COMMENTS ON SELECTED EPA
ASSUMPTIONS REGARDING
MERCURY CONTROL COSTS

*Submitted by the
Utility Air Regulatory Group
June 3, 2002*

SPRAY DRYING, COOLING: NOT THE SAME

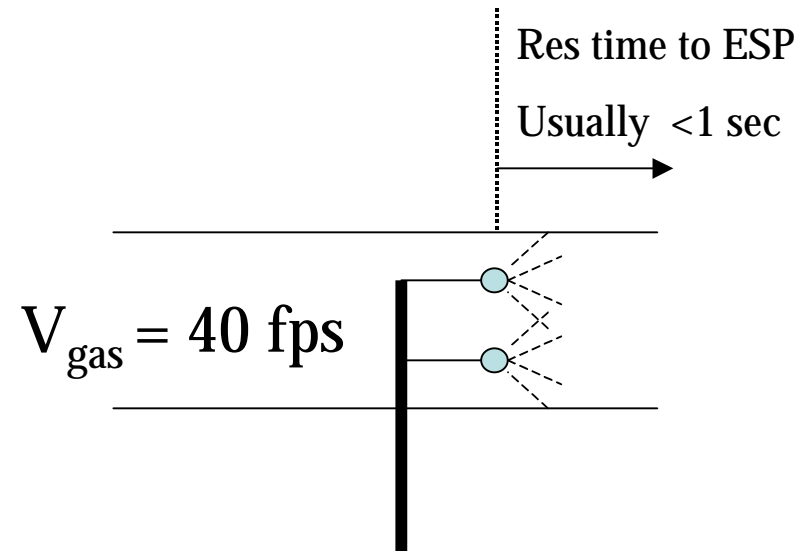
Capital: \$75-100/kW

Capital: \$2-3/kW

SPRAY COOLING AT PP4 DEMO (SOLE COMMERCIAL EXPERIENCE)

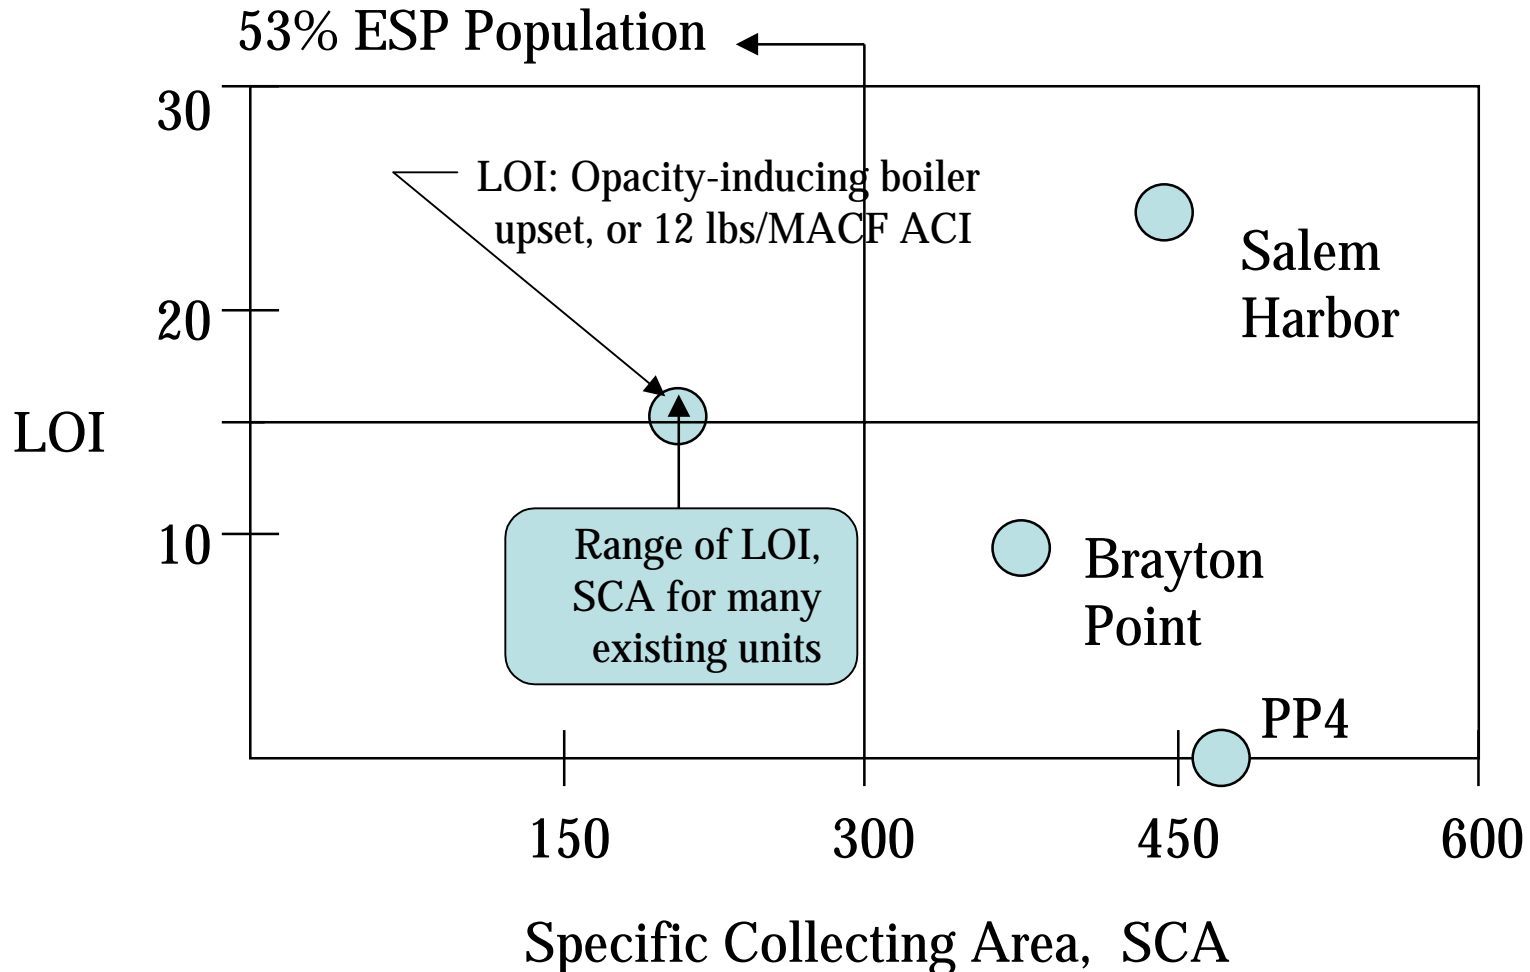
- Deposits noted via cameras within 1 hr operation
- Key areas of concern (flow vanes, baffles, ESP inlet, etc.) inaccessible to video monitor
- Deposits removable, but after injection terminated
- Significant finding: 50° F temperature drop did not benefit Hg removal, carbon utilization

KEY TO THE ESP: CARBON (LOI), SCA (RELATIVE SIZE)

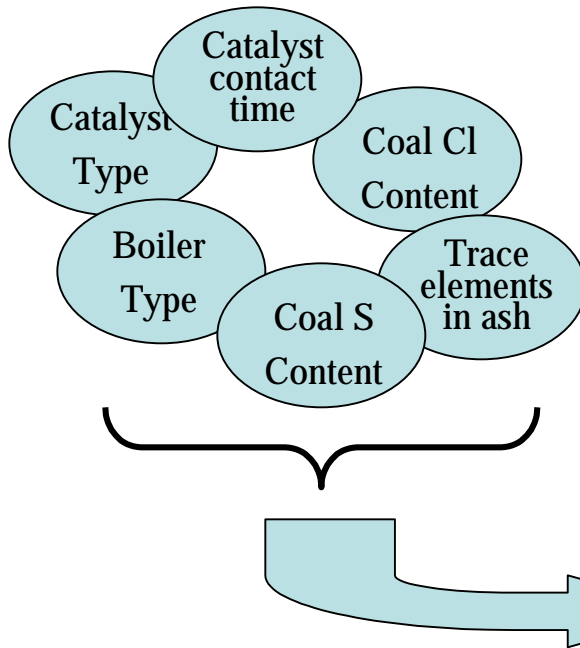
- PP4: one of the most ACI-tolerant ESPs
 - large SCA (465)
 - LOI < 1% (volatile PRB fuel)
- 53% of US ESP inventory
 - SCA < 300
 - 5-10% LOI---->10-15 with 12 lbs/MACF
- Units < 300 SCA will probably require ESP upgrade to tolerate ACI
 - capital \$17-24/kW, not \$2-4 /kW per EPA
 - total 2-3 mills/kWh, not < 1/kWh per EPA
